April 20, 2011

Thank you for the opportunity to attend PSE's Aquatic Resources Group meeting (by videoconference in January, and in person in March) to hear Tetra Tech's briefing on the Article 107(c) imminent flood drawdown analysis. The following are my comments related to this analysis.

The following comments apply to the January 11, 2011 technical briefing document:

The following comments apply to the March 4, 2011 technical briefing document:

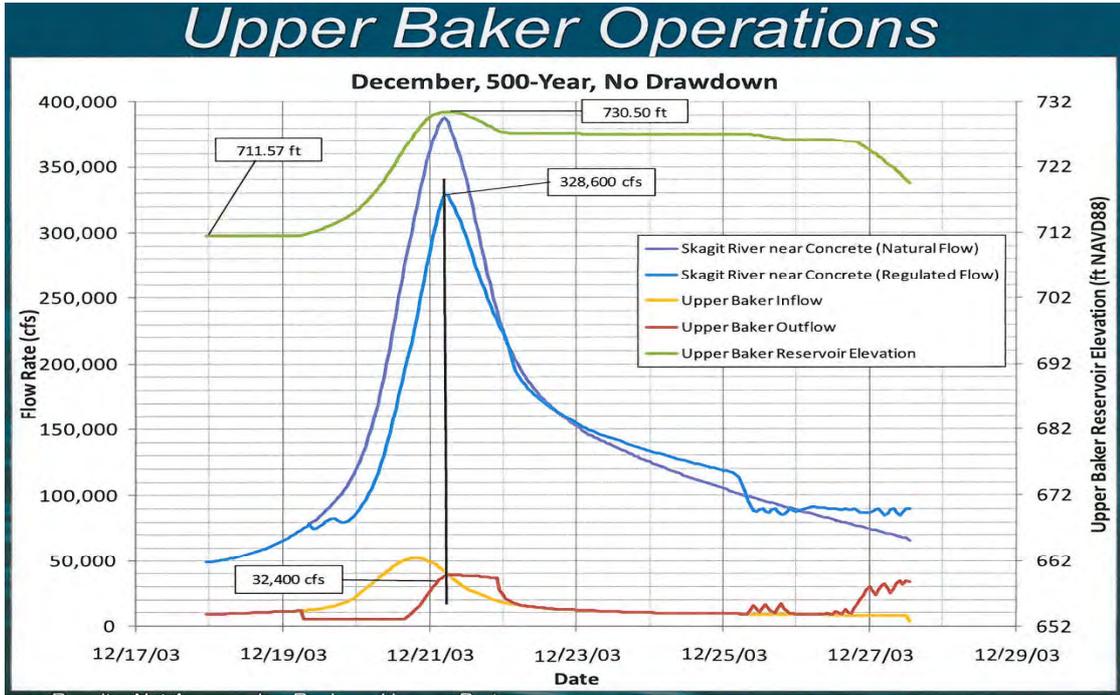
5. Slide #22 of 55, Upper Baker 500-year Ops: It is not clear to me what the 32,400 cfs annotation applies to. It appears to indicate the outflow of Upper Baker at the Skagit flood peak; however, it appears that outflow would be about 38,000 cfs from the graphic.

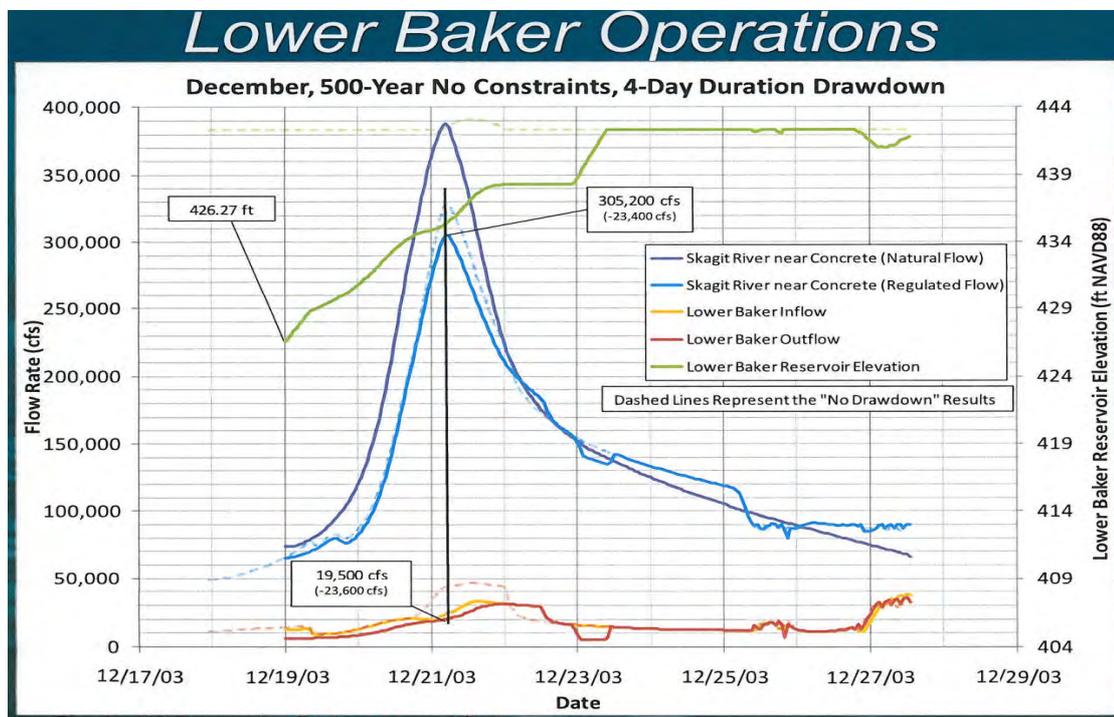
6. Slide #23 of 55, Lower Baker 500-year Ops: is this right? If the 500-year inflow to Lower Baker from Upper Baker, at the time of the Skagit flood peak, is about 38,000 cfs, it seems like the inflow from Lower Baker's basin would be 12,000 cfs or more at the same time, for a total closer to 50,000 cfs.

Lower Baker Operations

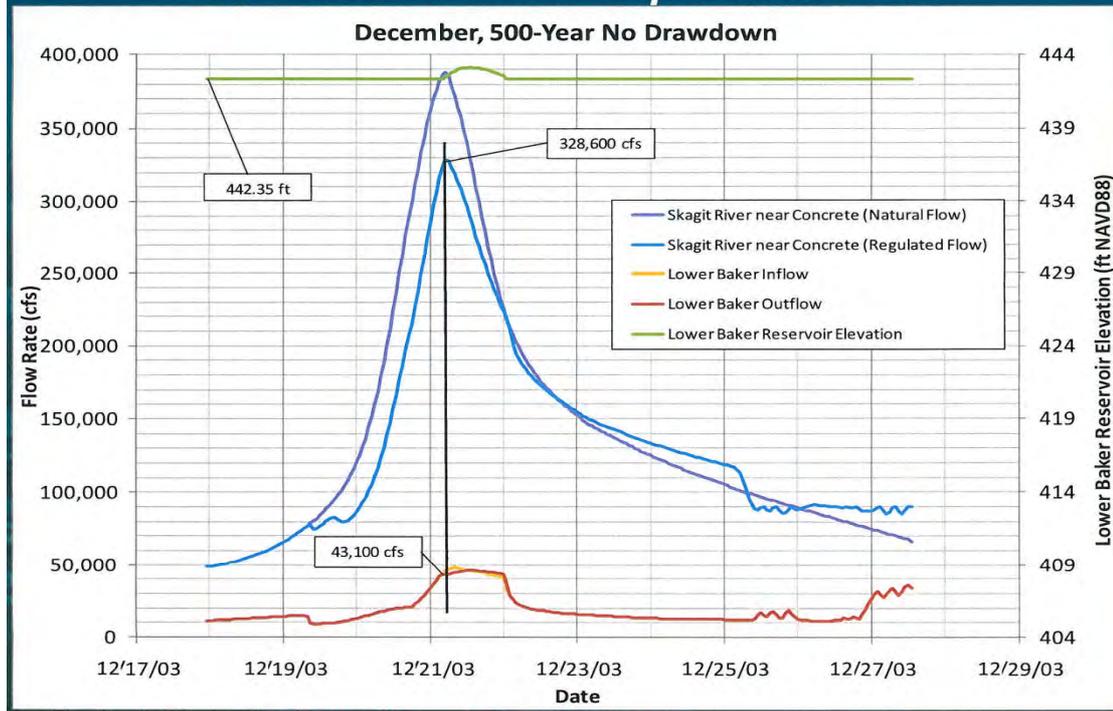
7. Slide #25 of 55, Lower Baker 500-year Ops: although it would not make much downstream difference in a flood of this magnitude, I would note that Lower Baker could still be used to reduce the Skagit peak by another 10,000 cfs or so, because the reservoir would still have some small amount of storage available prior to the Skagit flood peak and Concrete. This could be done by monitoring the flood peak on the Sauk above Whitechuck gage, as well as the Sauk gage, and then reducing outflow from Lower Baker shortly after the Sauk above Whitechuck gage crests, if it looks like the Sauk gage is rate of increase is slowing. There is an art to this but it can be done.

October, 2003 Baker River Project Inflow
 (Corps of Engineers, Hydrology and Hydraulics Report, August 2004)

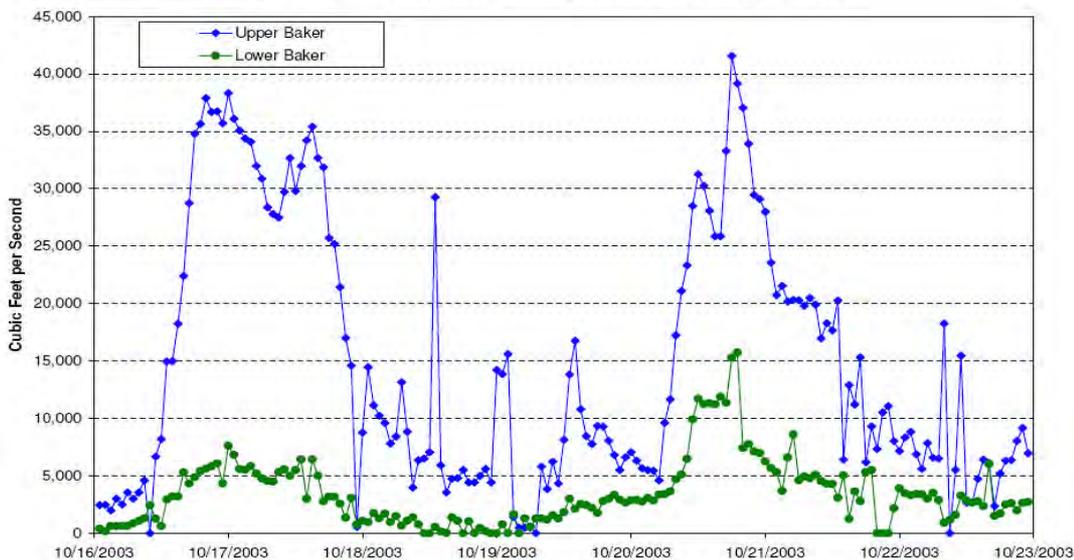
Note Lower Baker inflow for this flood was about 5,000 cfs or a little more at the time of the Skagit flood peak, with Upper Baker inflow at about 20,000 cfs or higher.

My rough calculations indicate that approximately 10 hours of storage would be available at the Lower Baker inflow rates for the “post IPP constraints” scenario if the project outflow was reduced to

zero starting 5 hours prior to the Skagit flood peak at Concrete. I assume that the Tetra Tech analysis uses the Corps Water Control Manual suggestion to pass Lower Baker inflow as a constraint. This is not the point of the imminent flood reservoir drawdown concept; in fact, the assumption here is that if an alternative operation can be found that reduces Skagit flood peaks, the water control manual would be modified to accommodate the alternative operation. So the water control manual should not be used as a constraint in the analysis. For the “no constraints” analysis, a couple more hours of storage would be available to absorb a complete shutdown of all project outflow. Several years ago, Puget Sound Energy indicated to Skagit County that it was willing to completely shut down Project electrical generation, with no compensation, for these limited few hours prior to and following a Skagit River flood peak.

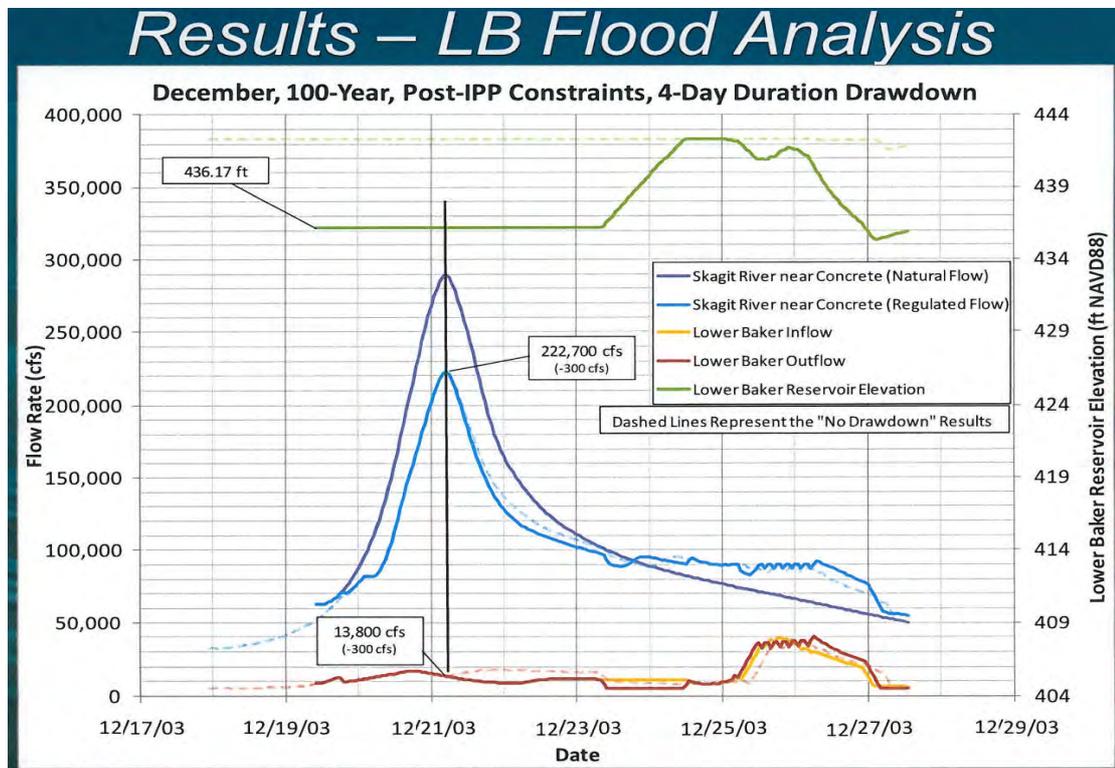
13. Slides #48 and 49: These two slides are very important and key to the analysis. Of note is the fact that Lower Baker releases approximately 14,000 cfs into the Skagit flood peak, while significant storage is still available in Lower Baker reservoir. Side note: I assume 14,000 cfs represents 5,000 cfs inflow from Upper Baker and 9,000 cfs natural inflow into Lower Baker. This seems low for a 100-year flood event. Below is the graphic showing inflow during the double pump October 2003 flood, generally considered to be about a 30 year event for the Skagit:

14. Slides 48 and 49: add another slide to this group showing the impact of reducing project outflow to zero for a 20-hour period beginning 10 hours prior to the flood peak at Concrete. This analysis may extend upstream to the Upper Baker reservoir, to the extent additional flood storage may be available in that reservoir that could be used to retain storage in Lower Baker.

Results – LB Flood Analysis

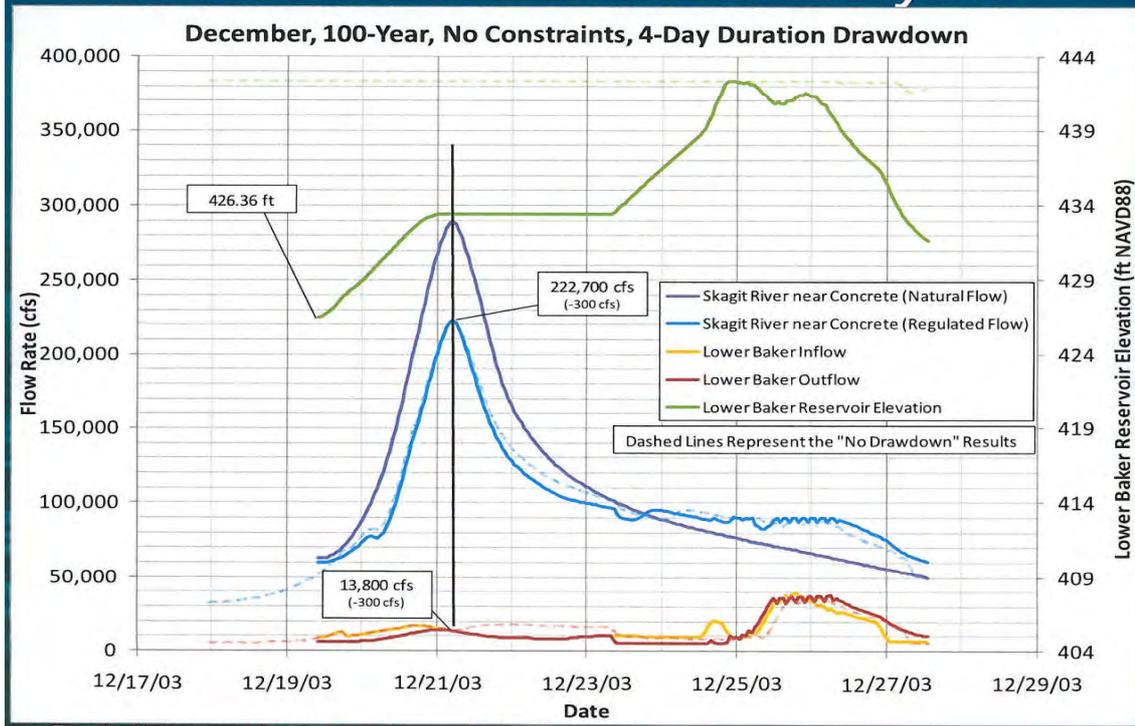
15. Slides #50-52: These three slides need to be modified to include the analysis showing the peak flow impact on the Skagit of reducing project outflow to zero during a window of time beginning 10 hours prior to the Skagit flood peak and extending 10 hours beyond the Skagit flood peak.

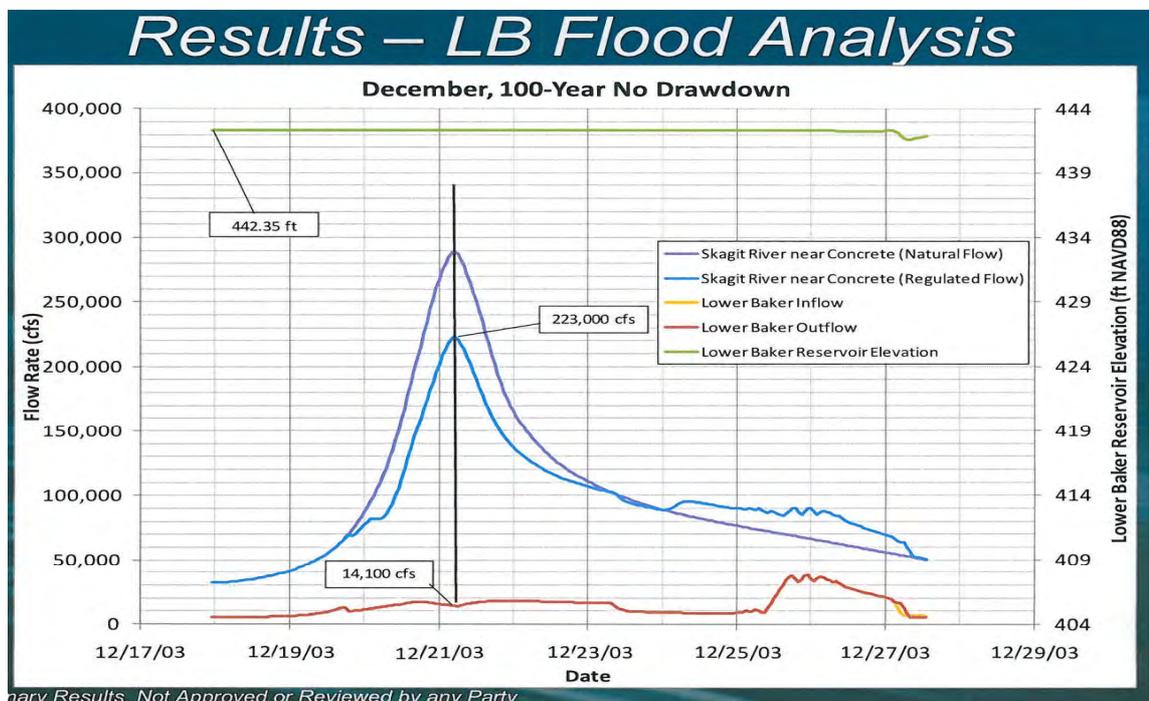
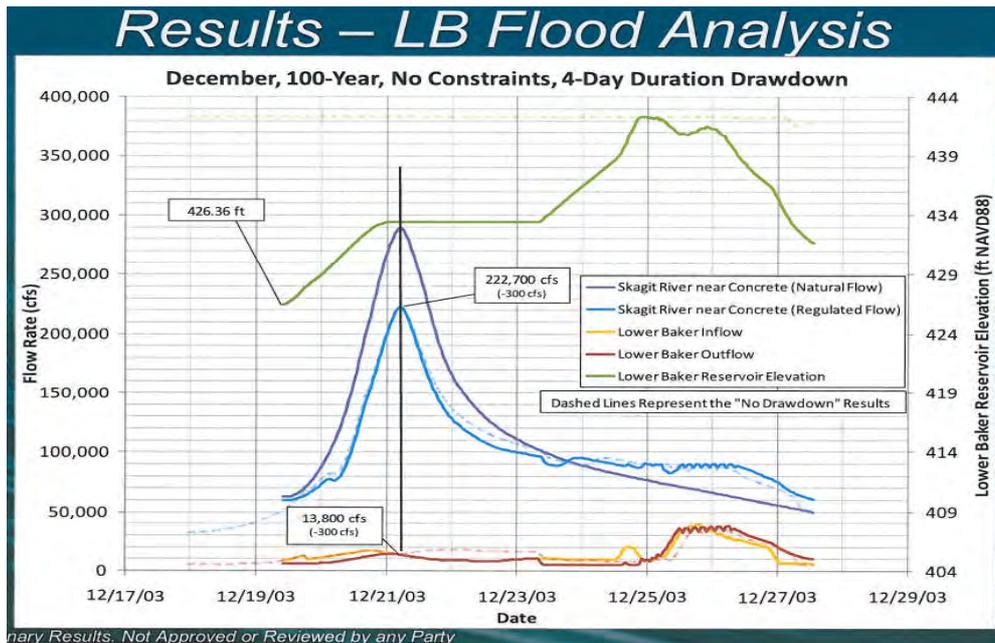
Therefore, the “delta” or difference shown on the slide above, based on the assumption of 5,000 cfs outflow from Upper Baker to Lower Baker, as well as passing Lower Baker’s own basin’s inflow, results in a difference of 14,100 cfs compared to 13,800 cfs as shown in the graphics below (from the January presentation):

First, the graphics above indicate that the synthetic hydrograph of the Lower Baker inflow (because the assumption is: inflow = outflow) is about 9,000 cfs for a 100-year Skagit flood event at the timing of the Skagit's peak at Concrete. Is this correct? It seems a little low for a 100-year event.
